From: Paul Mason
Sent: 24 February 2025 11:19
To: Ellie Knowles
Subject: Bus Depot, Queens Road App No. 141935/LO/2025

Listed Building Consent for external alterations to the eastern and western elevations to provide new access doors, along with internal modifications to facilitate the installation of EV charging infrastructure

Bus Depot Queens Road Manchester M8 8UT

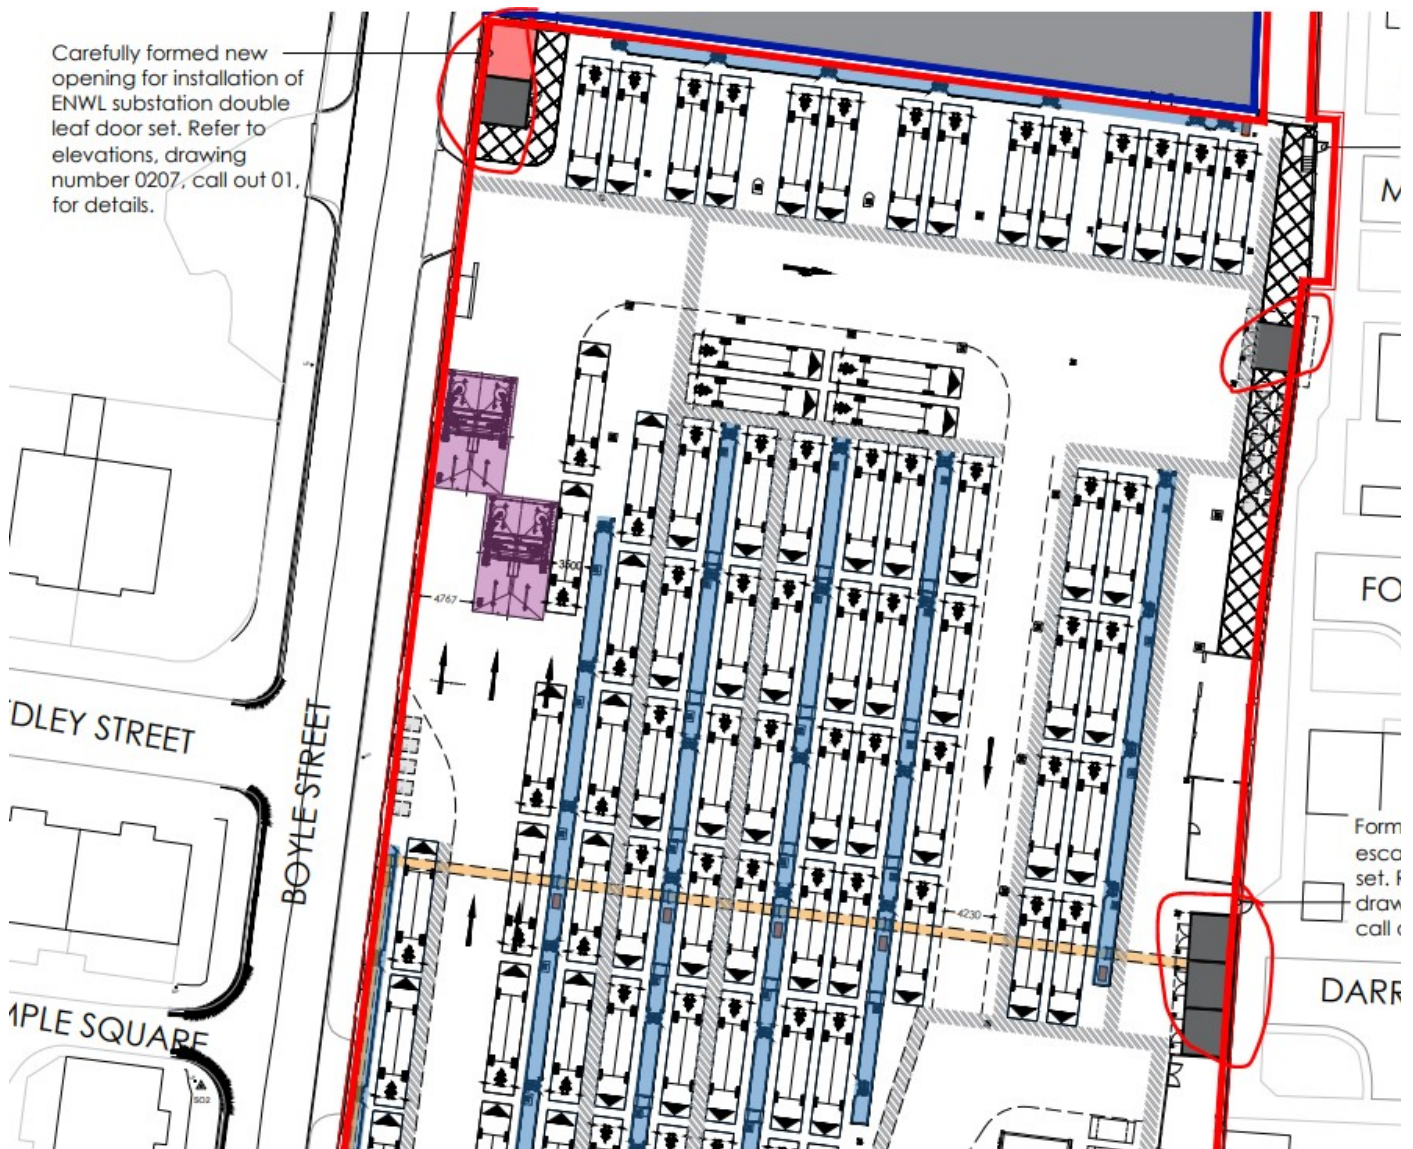
The proposed door in the location circled in red uses an existing window and widens the opening and extends the brickwork down. Doorways already exist in the elevation and this section of the building can take a new opening, without too much impact, provided it matches similar openings and doors. The image of the single door below shows a recessed door with brick returns and this gives the opening some interest and depth. The door also appears as a simple blue flat painted plain door. The proposed new door is proposed as grey coloured which will not match and it's not

clear whether the finish is flat or has a texture. It should be flat to ensure a match with the existing.

The door should be recess as per the image below and the brickwork formed to create the reveal to match. This ensures consistency in the treatment of openings. The proposal doesn't currently show a deep brick reveal or recessed door.
